## **PLAN REVIEW CONDITIONS**

Permit No: PRCOM20240579
Project Title: BEAUTY LOFT

Description: BEAUTY LOFT - TENANT FINISH

**NEW WORK FLOOR** PLAN/REFLECTED
CEILING PLAN

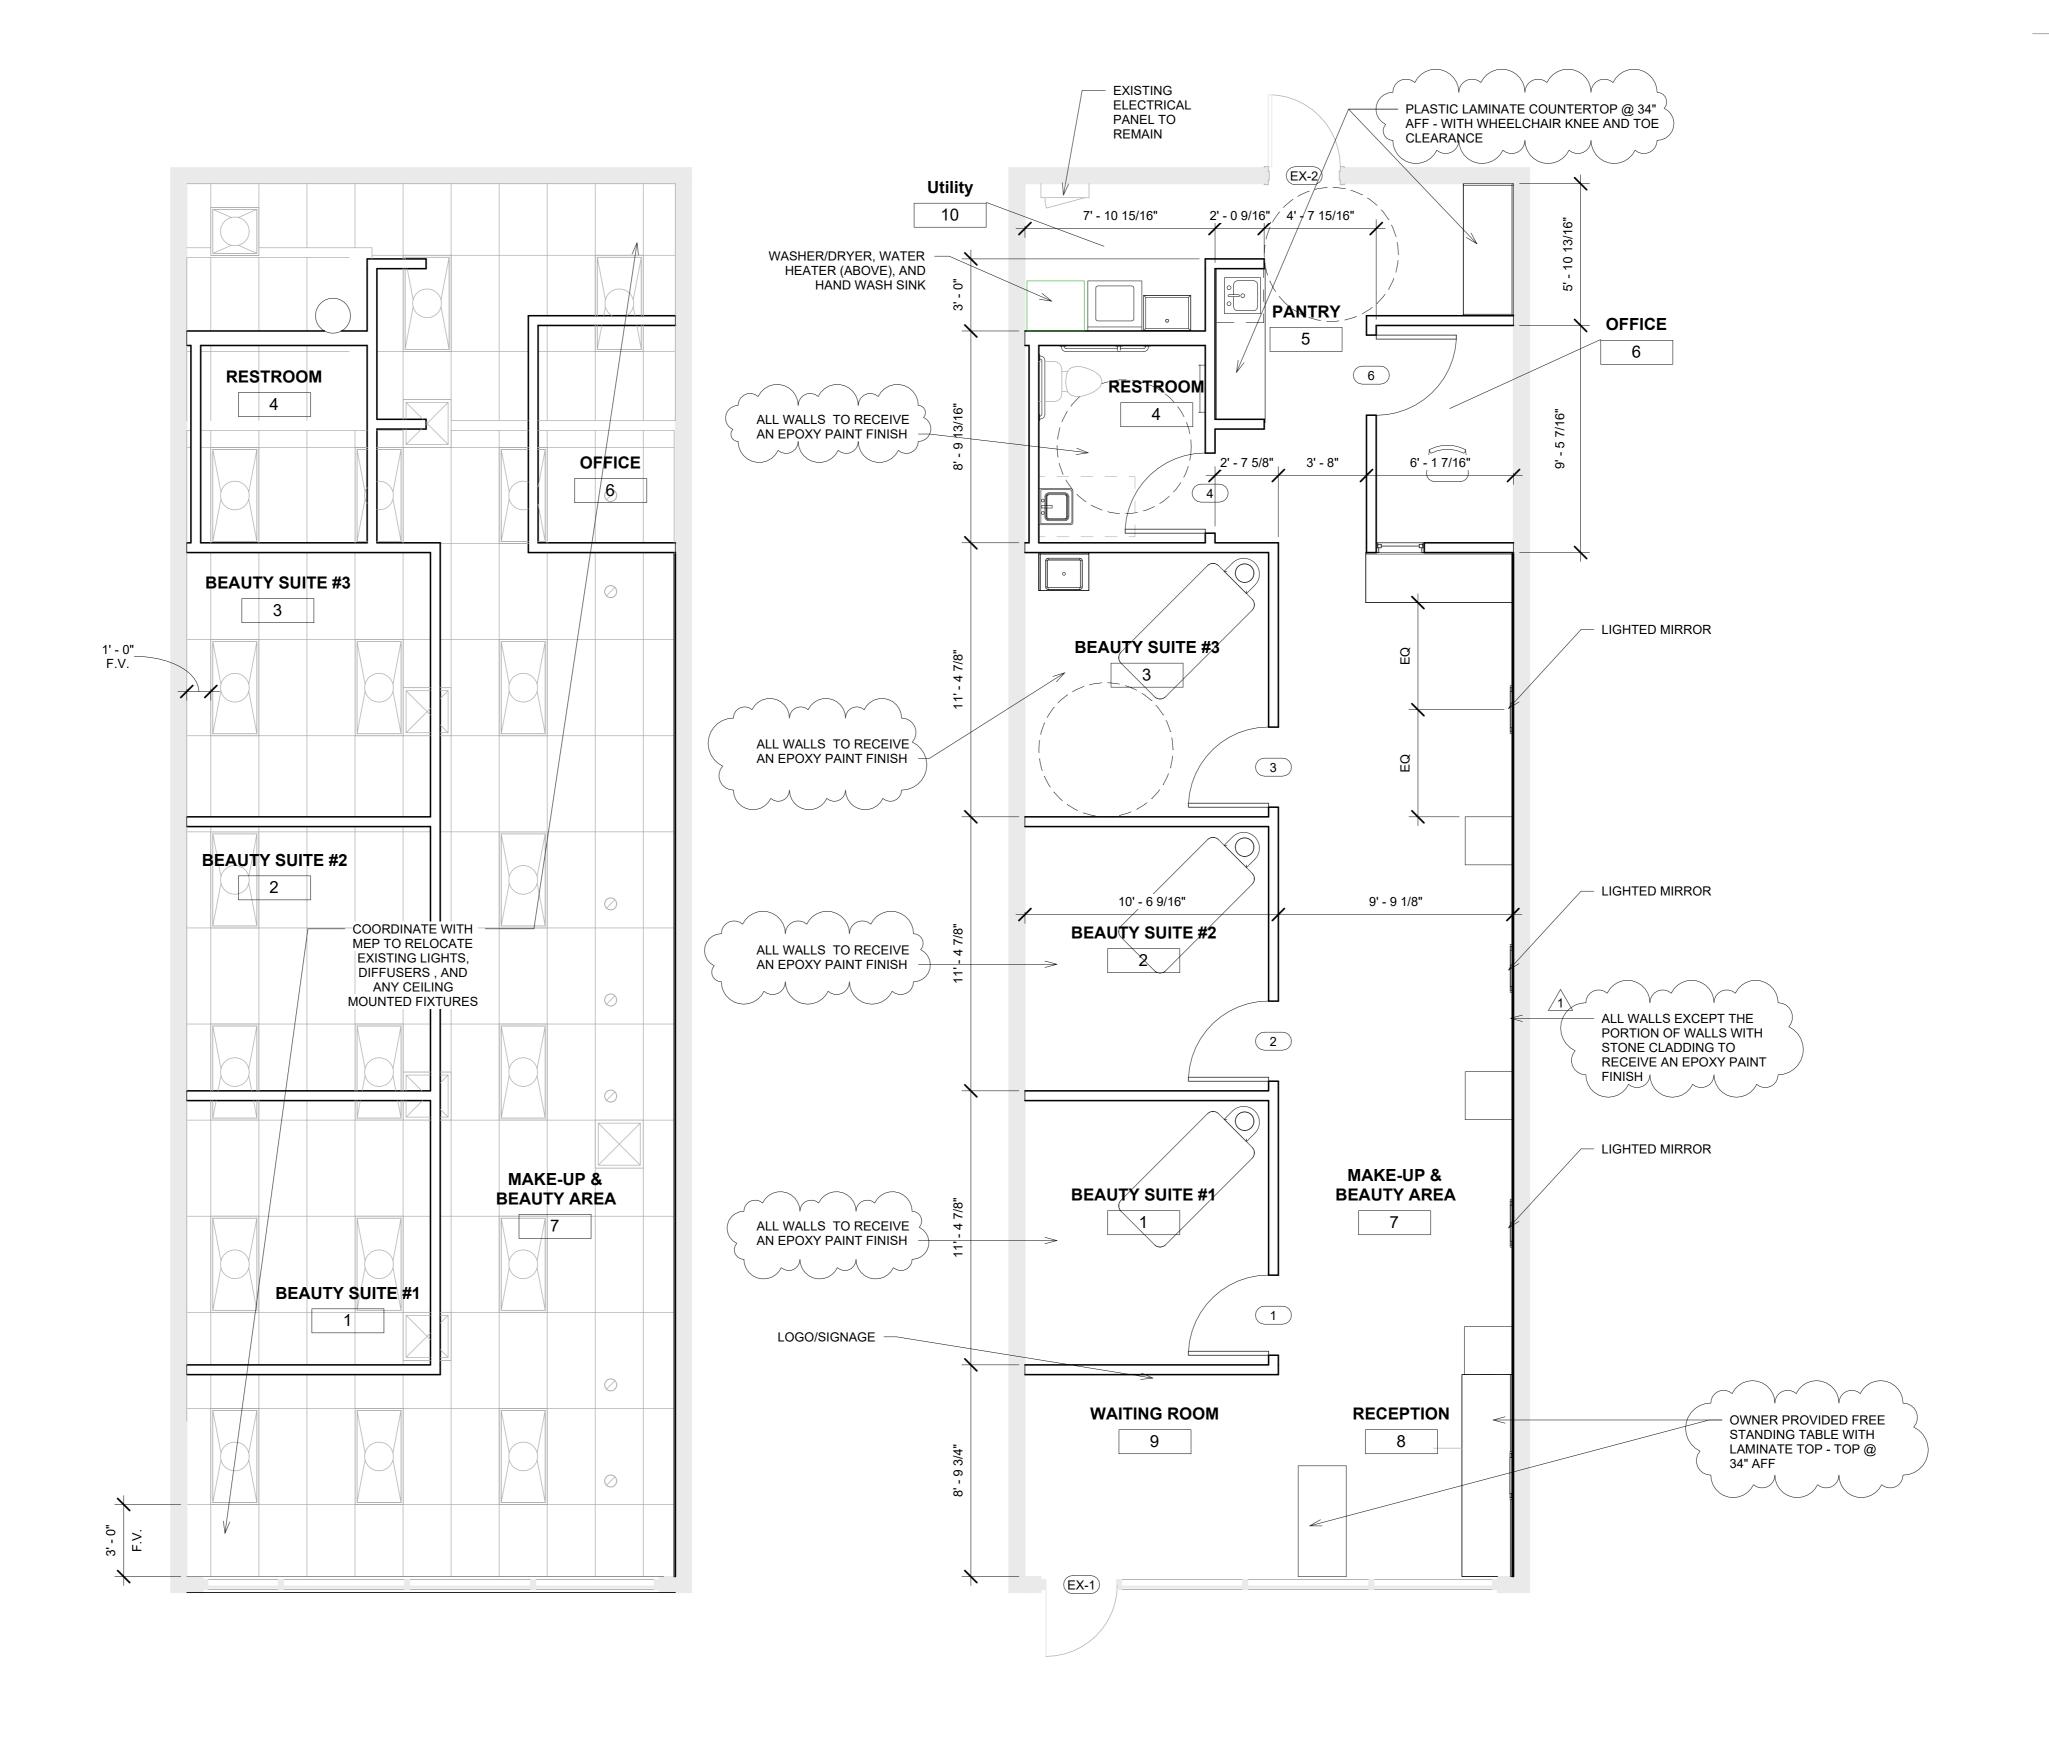
2. 2018 IBC 1109.11 Seating at tables, counters and work surfaces. Where seating or standing space at fixed or built-in tables, counters or work surfaces is provided in accessible spaces, at least 5 percent of the seating and standing spaces, but not less than one, shall be accessible. (see code for exception)

Action required: Modify/clarify design of Pantry cabinetry and sink to demonstrate compliance. (Maximum 34" a.f.f.) 3/5/2024 - Noted in letter but we need this on the drawings as our inspectors will not be reading the response letters. Revised A1.01 drawing attached.

3. ICC A117.1 Section 904.3 Sales and service counters and windows. Sales and service counters and windows shall comply with Section 904.3.1 and either 904.3.2 or 904.3.3. Where counters are provided, the accessible portion of the countertop shall extend the same depth as the public portion of the sales and service countertop provided for standing customers. (see code for exception) 904.3.1 Vertical barriers. At service windows or service counters, any vertical barrier between service personnel and customers shall be at a height of 43 inches maximum above the floor. (see code for exception regarding security glazing) 904.3.2 Parallel Approach. A portion of the public use side of the counter surface 36 inches minimum in length and 26 inches minimum and 36 inches maximum in height above the floor shall be provided. A clear floor space positioned for a parallel approach adjacent to the accessible counter shall be provided. The space between the accessible

counter surface and any projecting objects above the accessible counter shall be 12 inches minimum. (see code for exception) 904.3.3 Forward Approach. A portion of the public use side of the counter surface 30 inches minimum in length and 36 inches maximum in height above the floor shall be provided. A clear floor space positioned for a forward approach to the accessible counter shall be provided. Knee and toe clearance complying with Section 306 shall be provided under the accessible counter. The space between the accessible counter surface and any projecting objects above the accessible counter shall be 12" minimum.

Action required: Modify/clarify design to demonstrate compliance at reception desk. (at least 36 linear inches must be maximum 36" a.f.f.)

5. 2018 IBC 1209.2 Finish Materials. Walls, Floors and partitions in toilet and bathrooms shall comply with Sections 209.2.1 through 1209.2.4.

2018 1209.2.1 Floors and wall bases. In other than dwelling units, toilet, bathing and shower room floor finish materials shall have a smooth, hard, nonabsorbent surface. The intersections of such floors with walls shall have a smooth, hard, nonabsorbent vertical base that extends upward onto the walls not less than 4 inches.

2018 1209.2.2 Walls and partitions. Walls and partitions within 2 feet of service sinks, urinals and water closets shall have a smooth, hard, nonabsorbent surface, to a height of not less than 4 feet above the floor, and except for structural elements, the materials used in such walls shall be of a type that is not adversely affected by moisture. (See code section for possible exceptions.)

Action required: Specify compliant wall finish materials at service sink and toilet. If paint is used it must be epoxy based. 3/5/2024 - Noted in letter but we need this on the drawings as our inspectors will not be reading the response letters. Revised A1.01 drawing attached.

3/5/2024 - Noted in letter but we need this on the drawings as our inspectors will not be reading the response letters. Revised A1.01 drawing attached.
